PROJECT NAME: MILTON
PROJECT NUMBER: STP 5800 (2)

FILE NAME: t92d289bdr.dgn
PROJECT LEADER: J. SCHULTZ
DESIGNED BY: D. LYMAN
DRAINAGE LAYOUT 1

PLOT DATE: 23-FEB-2011
DRAWN BY: D. LYMAN
CHECKED BY: J. DEVLIN
SHEET 30 OF 104

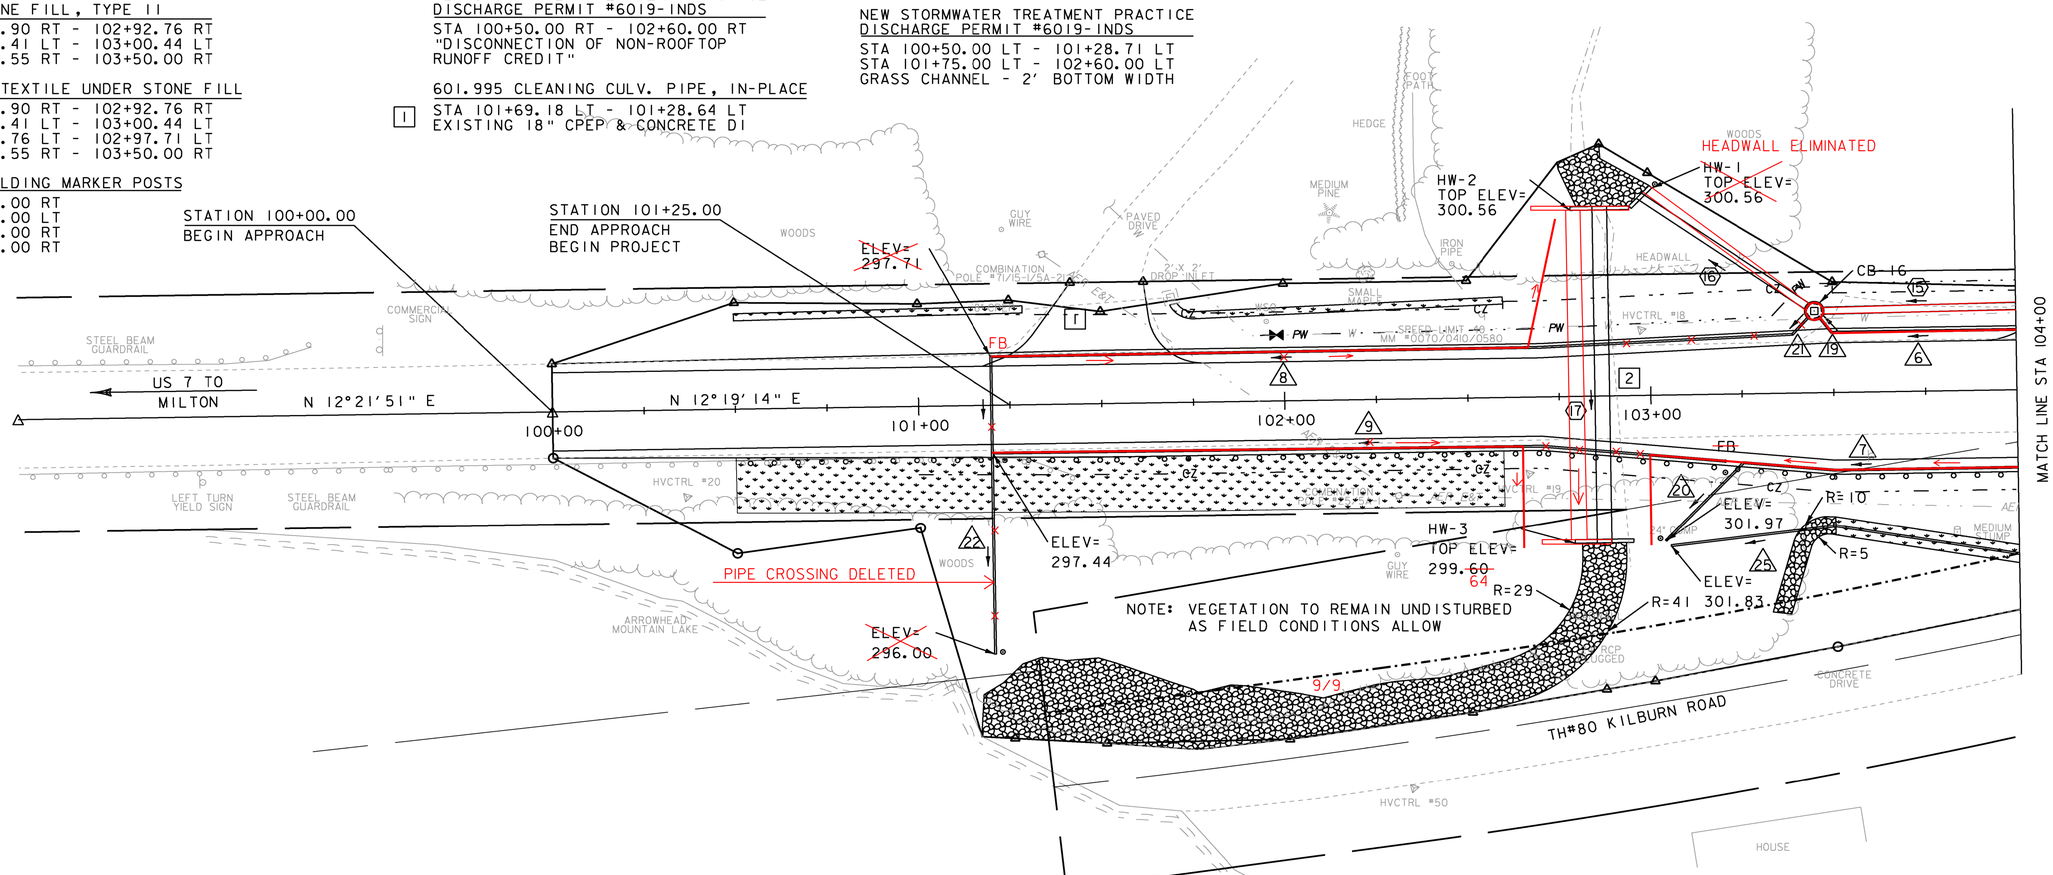
⑰ STA 102+~~86.76~~ 80.0 LT - 102+~~86.76~~ 80.0 RT
NEW 48" X 95' PCCSP/CAAP
W/REINFORCED CONCRETE HEADWALL (TYP) @ INLET
W/REINFORCED CONCRETE HEADWALL (TYP) @ OUTLET

⑨ STA ~~103+20.00~~ 102+65 RT - 101+20.00 RT
NEW 6" X 200' UNDERDRAIN PIPE
W/FLUSHING BASIN @ STA ~~103+20.00~~ 101+20 RT
